10 Dowry Square, Hotwells

Addendum to Design and Access / Heritage
Statement setting out proposed changes to
22/01475/H and 22/01620/LA

EMMETT
RUSSELL
architects

Ground Floor Plan - Consented Scheme

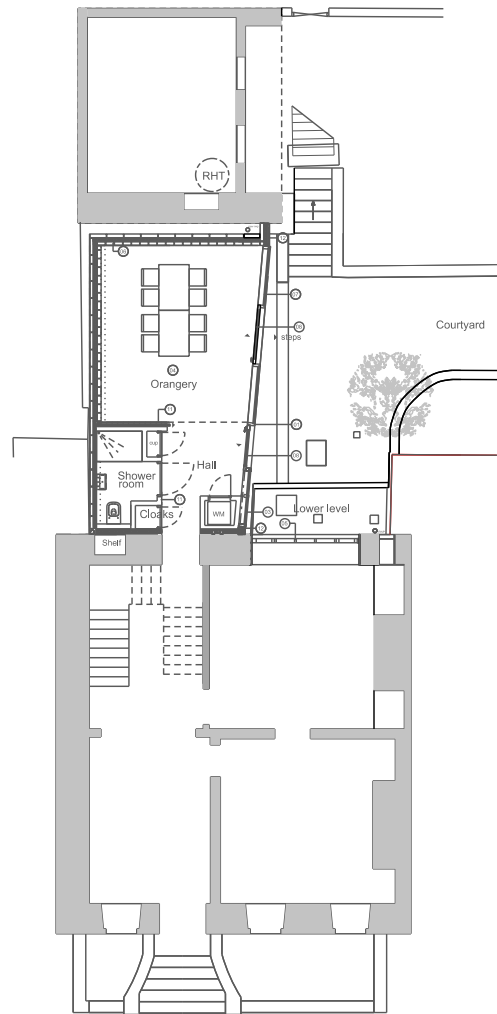
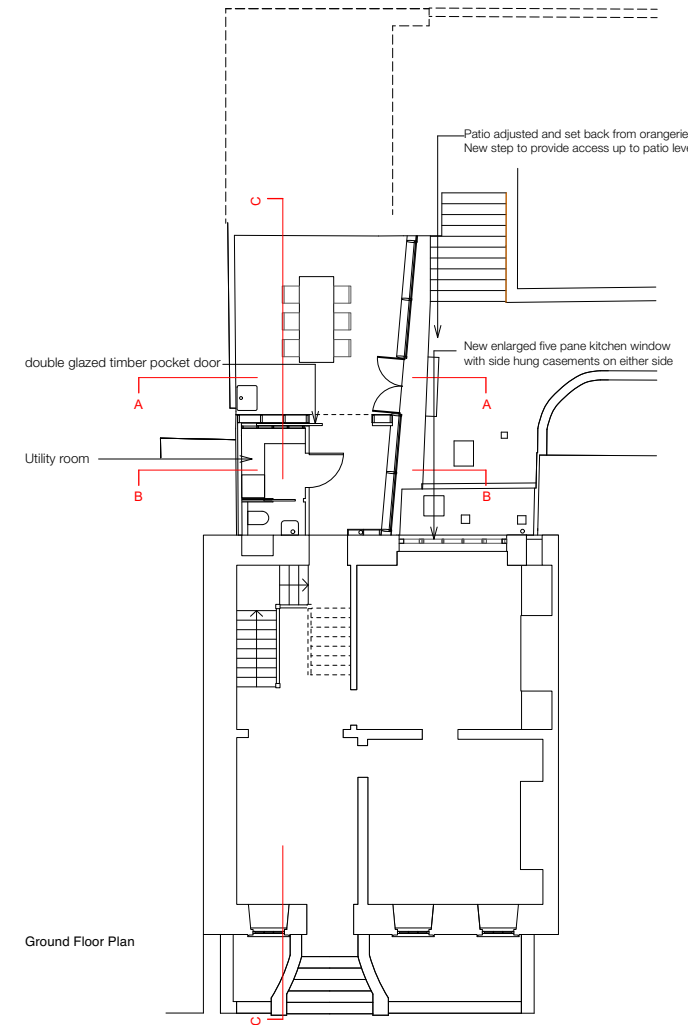
The currently consented scheme assumes that the whole extension will be a heated space within the thermal envelope of the main house. It therefore includes a new insulated cavity wall around the conservatory space. The revised proposal has a less disruptive approach that retains the existing exposed stone / brick boundary wall within the conservatory space and omits the new cavity wall construction along the boundary. There will also be less ground work and excavations for foundations with this approach. The conservatory is treated as an unheated conservatory space with substantial planting. The new thermal enclosure within the extension is limited to the WC, utility room and study.

First Floor Plan - Consented Scheme

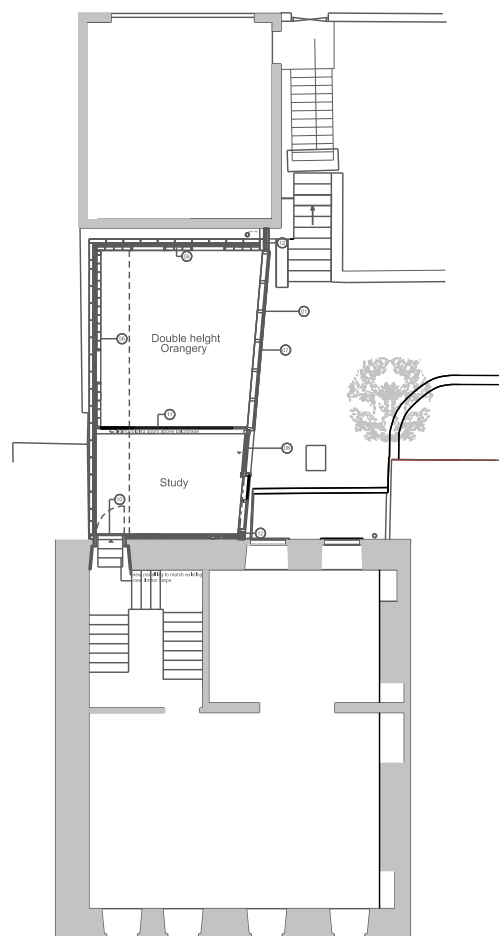
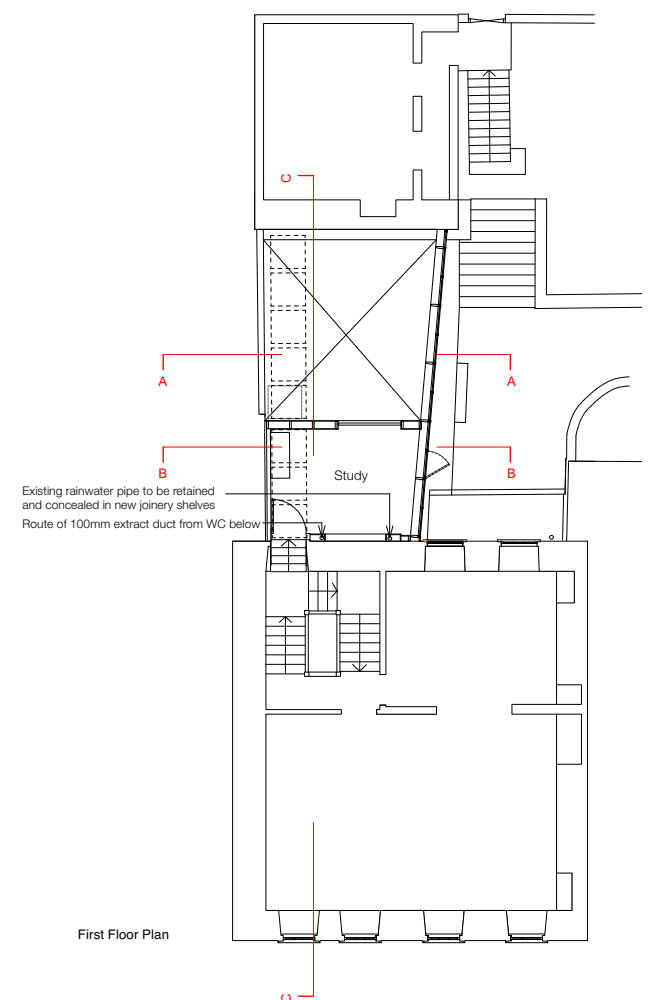
The first floor plans on this page of the consented scheme and the revised proposal show the omission of the new cavity wall on two sides of the double height orangery space.

Cross Section - Consented Scheme

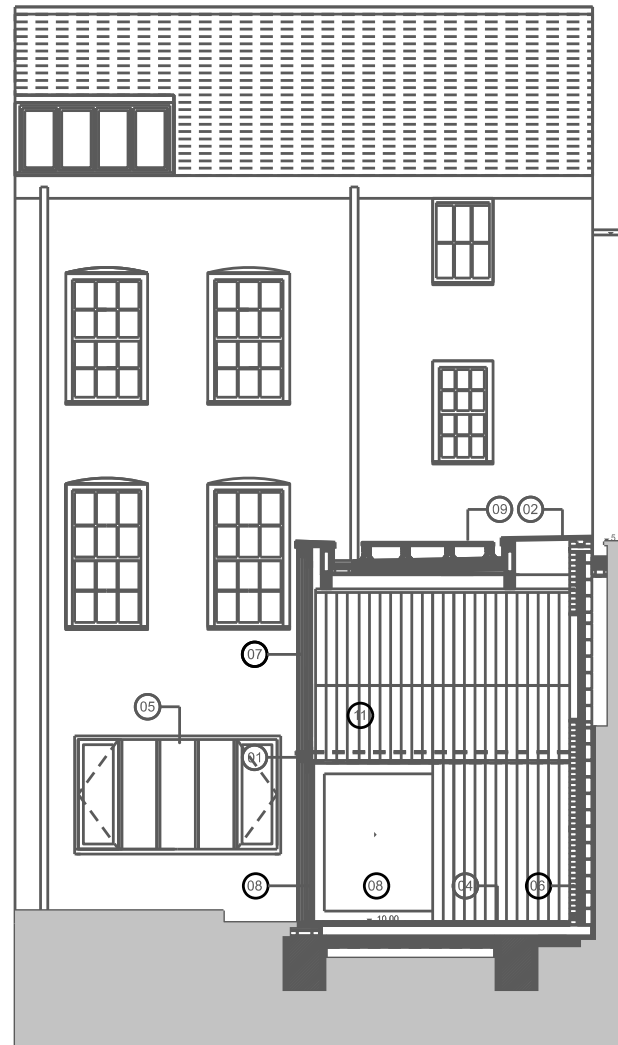
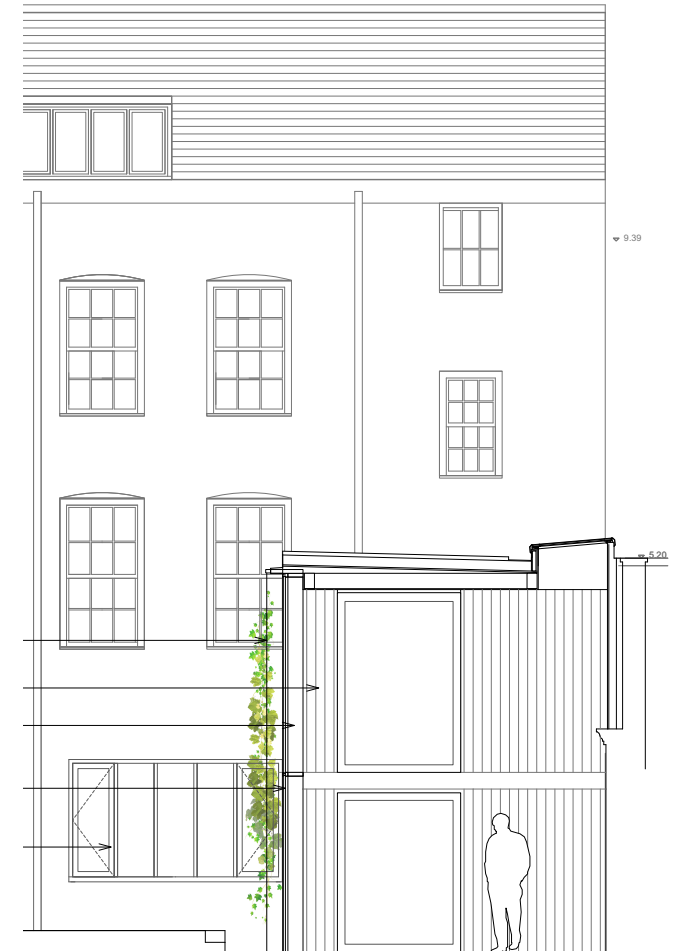
The Cross sections on this page compare the currently consented scheme with the revised proposals. The omission of the new cavity wall construction adjacent to the party wall is clear in these cross sections.

The currently consented scheme has a single-ply membrane roof membrane with paving slabs suspended above. The revised proposal is for a standing seam zinc roof which is more appropriate for the heritage setting and has a much longer expected life span.

The two cross sections on this page show the difference in form between the original single ply membrane roof and the proposed zinc roof.

Roof Plan - Consented Scheme

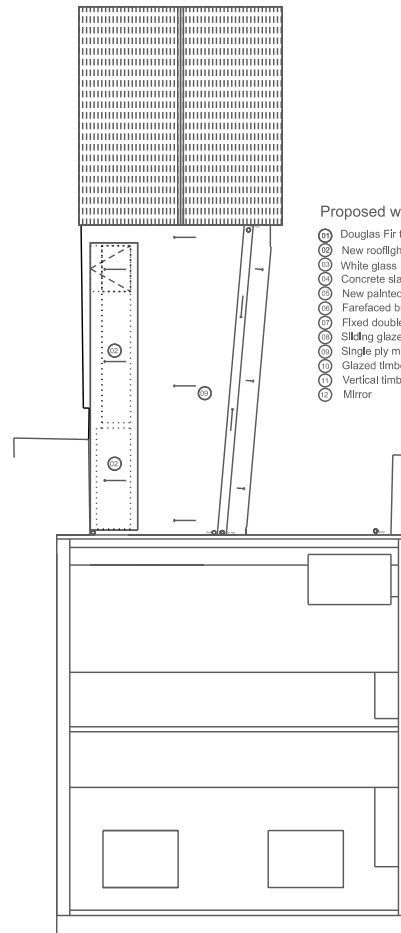
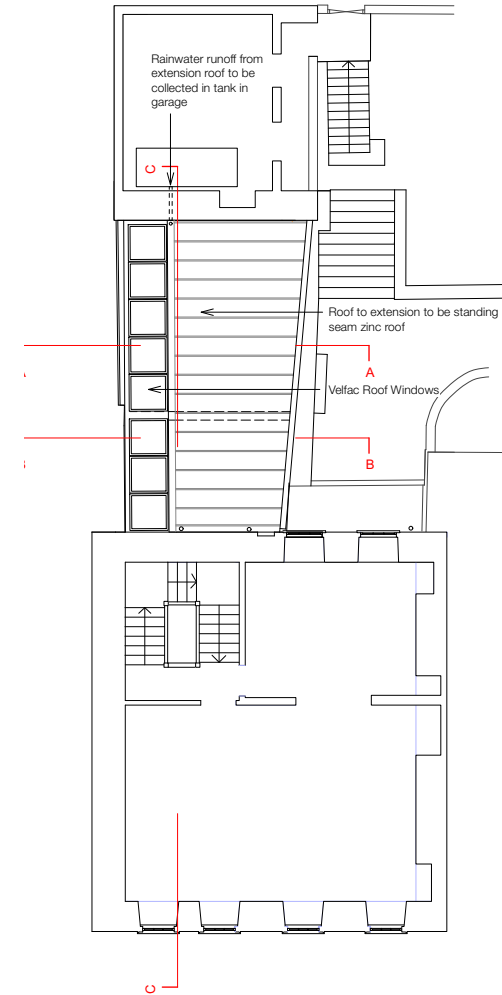
In order to provide sufficient ventilation and avoid overheating in the conservatory space we have proposed a slightly different roof light system - the Velux Modulator roof light system that allows fixed and opening roof lights within the same frame profile.

The roof plans on this page show the consented scheme and the proposed revised scheme. This illustrates the new roof light arrangement and the new standing seam zinc roof.

Section / Elevation - Consented Scheme

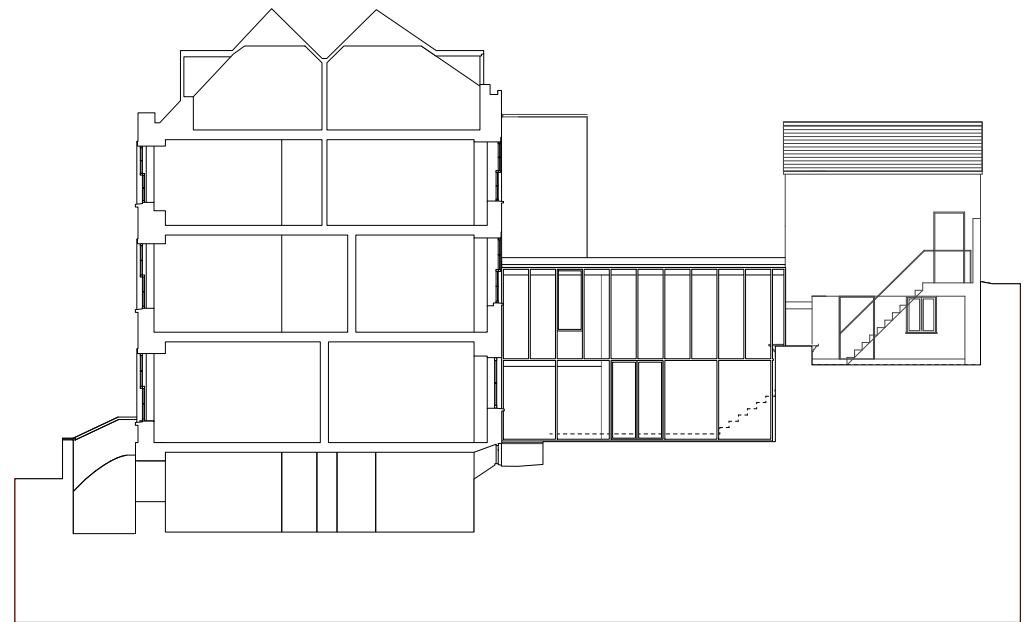
The two drawings on this page show the consented and proposed elevation of the new extension. The changes are relatively minor and only really relate to detailed seeing out.
